Product Change Notice (PCN)

件名： RL78/F12, F13, F14 シリーズ、SSOP 製品の Cu ワイヤ化

発行日： 12/25/2024

マーク例

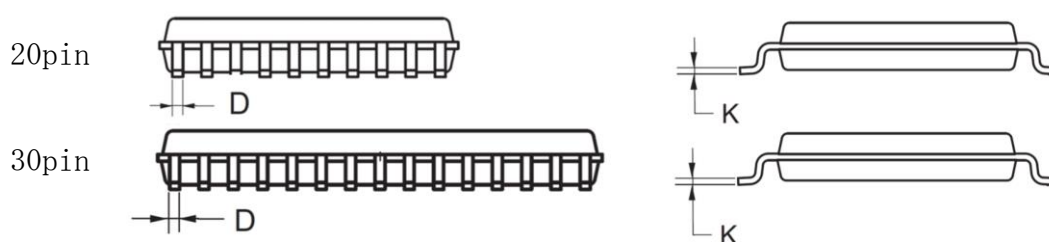
製品型名の変更に伴い、以下の通り、一段目の製品型名部分が変更になります。
